DfE John Flamsteed Community School
Derby

Planning Additional Clarifications
5/11/26

Architect Gas Membrane Details

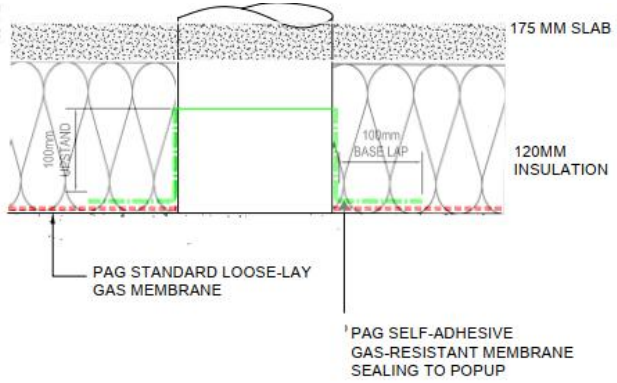
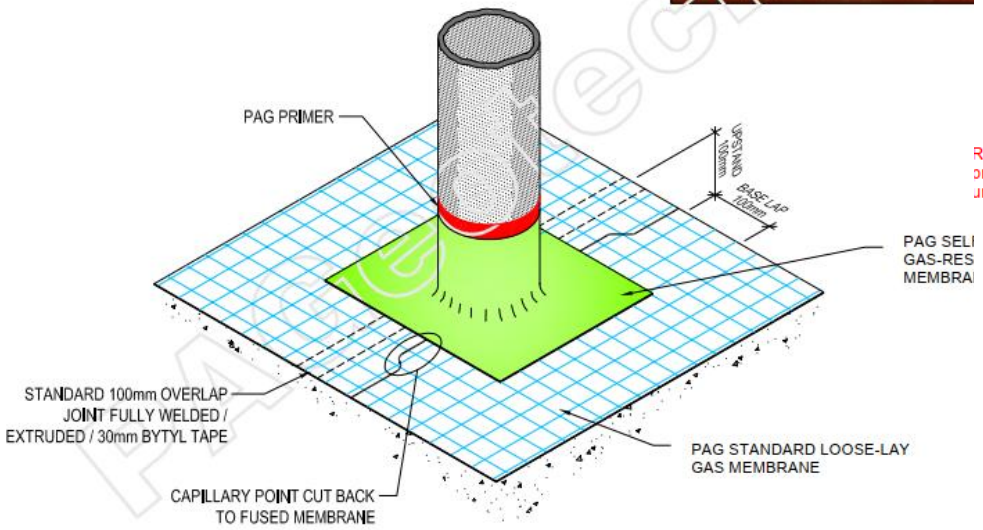
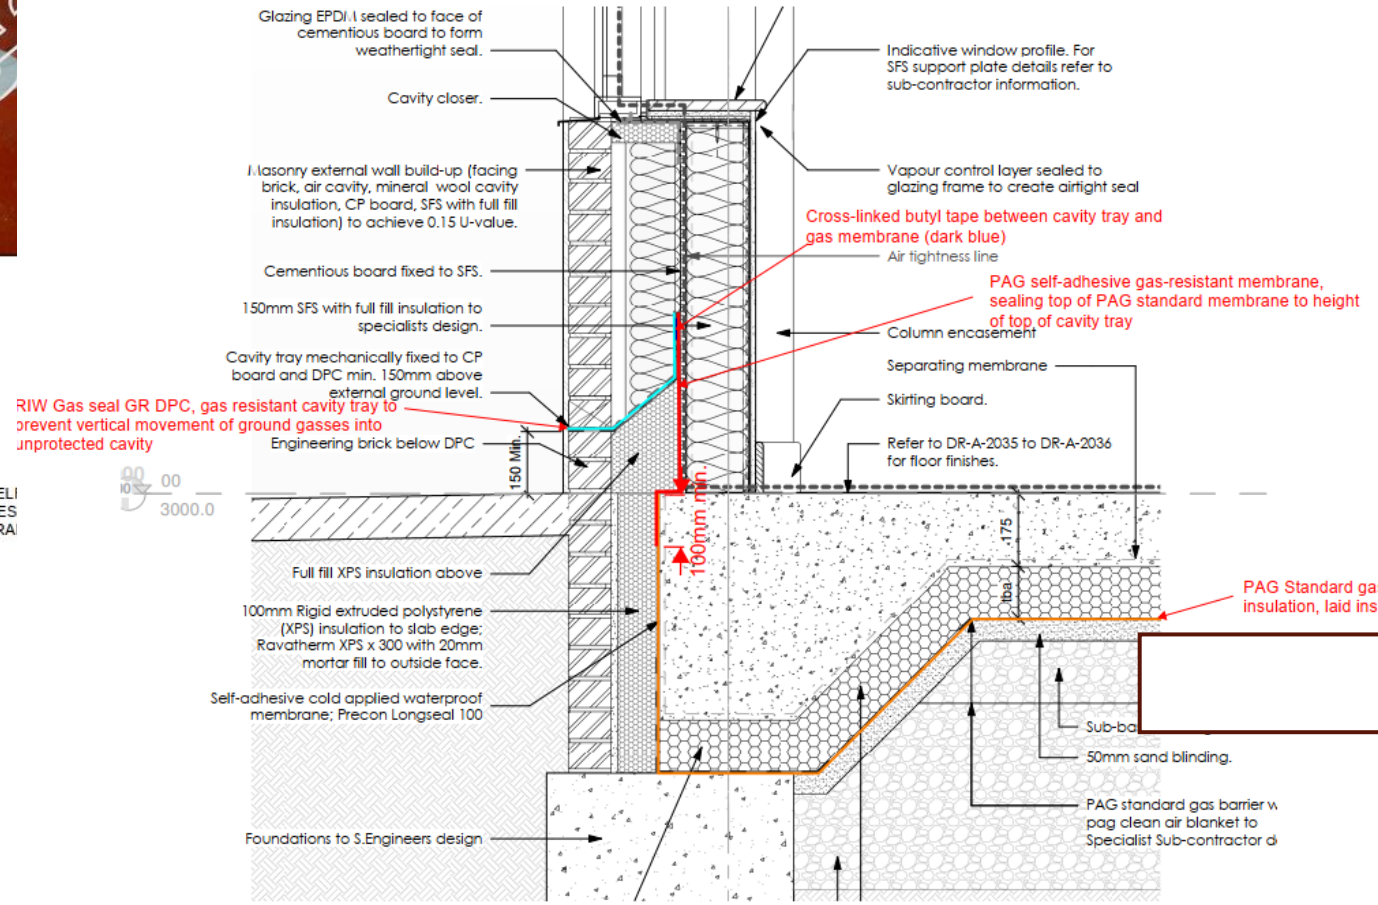
Note – Pageo Specialist details will be appointed and will provided in Stage 5 when Pageo are appointed for the works.

Information provided confirms the following :-

Requirements to meet :-

- BS8485:2015+A1:2019
- independently validated in line with CIRIA C735 in combination with the 250mm thick RC suspended slab
